Access Compliance Report

Public Rights-of-Way

(Curb Ramps)

Intersection ID: 10035175	Main Street: QUAIL_HILL_RD	Cross Street: N/A	Location: W
ADA ID: 6B6BF15D9B24	Ramp Type: Perp	Initial Pass/Fail: Fail	Overall Compliance: No
		Severity Score: 8.75

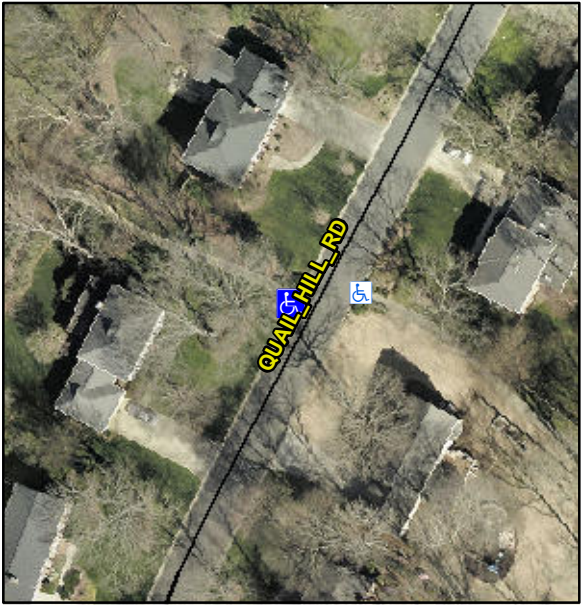
Codes/Mitigation Info/Possible Solution			Field Measurements/Component Compliance		
	Possible Solutions:		Compliance	Description	Data
	Remove & Replace Entire Ramp.		N/A	Ramp Length (in)	48.0
			No	Ramp Width (in)	47.0
			N/A	Flare Type LT	N/A
			N/A	Flare Slope LT (%)	N/A
			N/A	Flare Traversable LT?	N/A
			N/A	Landing Length (in)	N/A
			N/A	Landing Width (in)	N/A
			N/A	Landing Slope (%)	N/A
			N/A	Landing X Slope (%)	N/A
<p>Surveyor Notes:</p> <p>N/A</p> <p>PROW/ADA:</p> <p>R304.5.1</p>			N/A	Flare Type RT	N/A
			N/A	Flare Slope RT (%)	N/A
			N/A	Flare Traversable RT?	N/A
			N/A	DWS Provided?	N/A
			N/A	DWS Contrast?	N/A
			N/A	DWS Length (in)	N/A
			N/A	DWS Full Width?	N/A
			N/A	DWS Offset (in)	N/A
			N/A	Shared Landing?	N/A
			N/A	Gutter Ponding?	N/A
			N/A	Gutter Lip Ht (in)	N/A
			N/A	Painted X Walk1?	No
				X Walk 1 Direction	To E
			N/A	X Walk 1 Width (in)	N/A
				X Walk 1 Slope (%)	10.0
				X Walk 1 X Slope (%)	0.8

N/A	Ramp inside XWalk1?	N/A
			N/A	Road Slope (%)	N/A
			N/A	Road X Slope (%)	N/A
			N/A	Any Obstructions?	N/A
				Obstruction Type	
			N/A		N/A
			Yes	Surface Condition? (G/P)	Good
